**MEMORANDUM**

**To:** Mayor White and Members of Council  
**Copy:** Ms. Denise Holmes, CAO  
**From:** Chris Jones MCIP, RPP  
**Date:** November 9, 2017  
**Re:** Application for Official Plan and Zoning By-law Amendment (Strada)

**Re: Review of report entitled Combined Level 1 and 2 Hydrogeological Assessment, Proposed Bonnefield and Prince Pits, Melancthon Township, prepared by Whitewater Hydrogeology Ltd. on behalf of Strada Aggregates, May 2017**

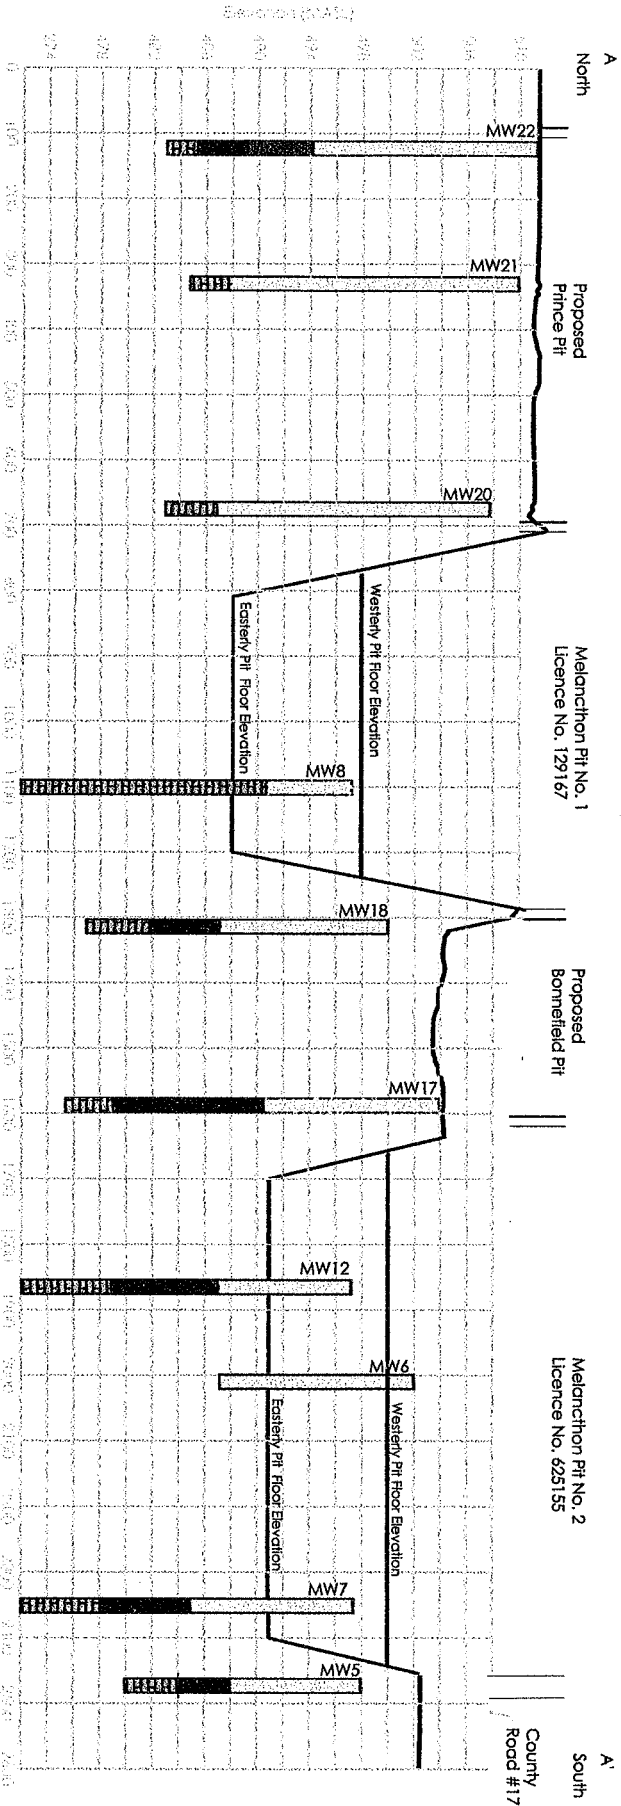
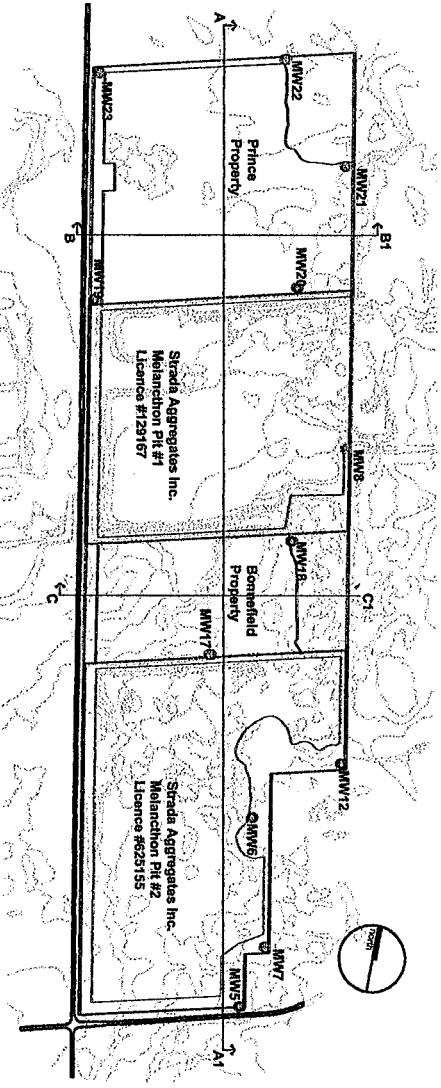
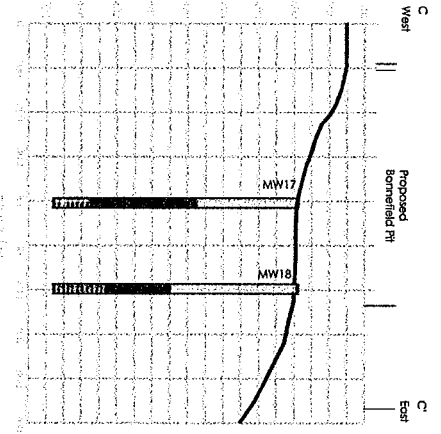
- 2. The nomenclature used for the monitoring wells in figure 6 is not consistent with the rest of the report. Please consider revising. Furthermore, based on the new monitoring wells, an east-west geological cross section is encouraged for the proposed Bonnefield pit.**

- The nomenclature used for the monitoring wells in figure 6 is not consistent with the rest of the report. Please consider revising. Furthermore, based on the new monitoring wells, an east-west geological cross section is encouraged for the proposed Bonnefield pit.

*An East-West geological cross section through the Bonnefield Pit is appended.*

FIGURE 1: OVERBURDEN HYDROGRAPH

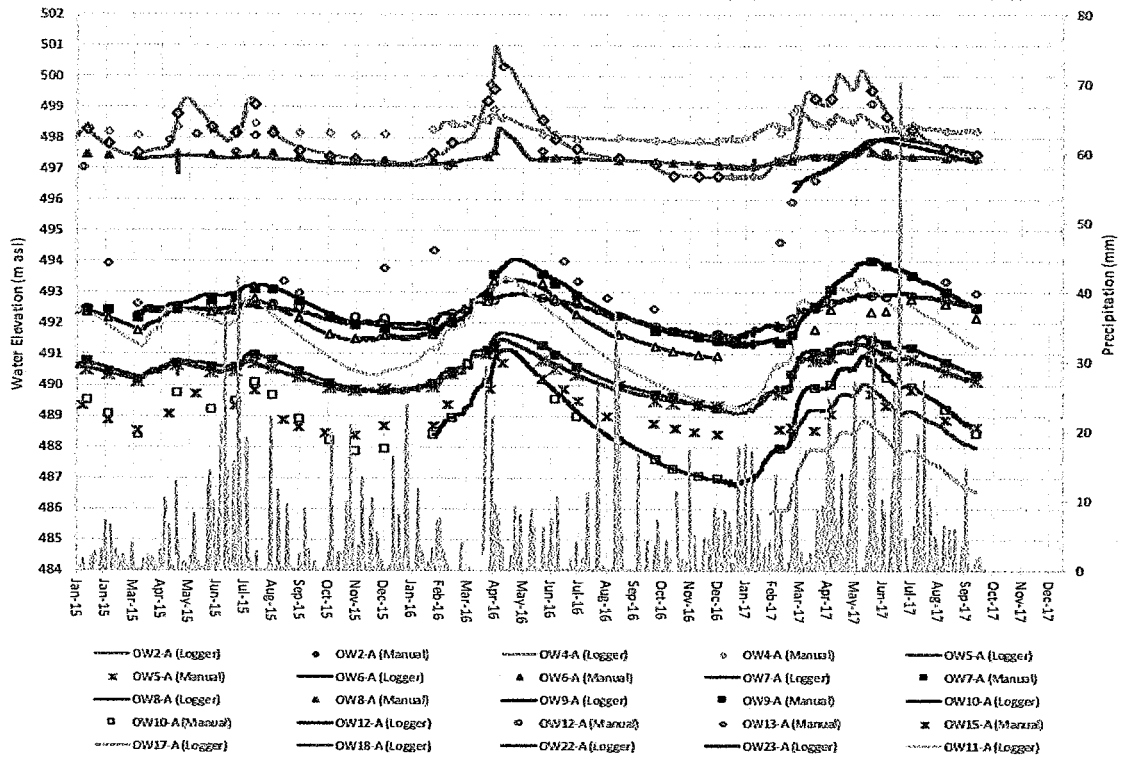
Whitewater (2017) recommended that the 2017 spring monitoring results be evaluated to confirm (or refute) the estimated high water levels for the new groundwater monitoring wells and the proposed final pit floor elevations. The updated water level data is presented in Table 1 and Figure 1.

Water level trends in the unconfined overburden aquifer are seasonal, with water levels peaking in the spring and decreasing over the warmer and drier summer months. In 2016, the seasonal trend showed this characteristic trend where groundwater levels peaked in April after the spring freshet, then slowly declined through the summer months. In contrast, the water levels in 2017 continued to rise in increments (three notable peaks) into May and remained relatively high for the summer months. This response is a result of the significant amount of precipitation that has fallen in 2017 (Figure 1).

Of particular interest to this assessment are the peak water level elevations reported over the monitoring period. In 2017, the highest manual water level elevations were reported on May 23<sup>rd</sup>. These values have been compared to April 2, 2016, values (true and estimated) to ensure that the proposed floor elevations presented in the Level 1 and 2 Hydrogeological Report comply with the requirement to remain 1.5 m above the established water table.
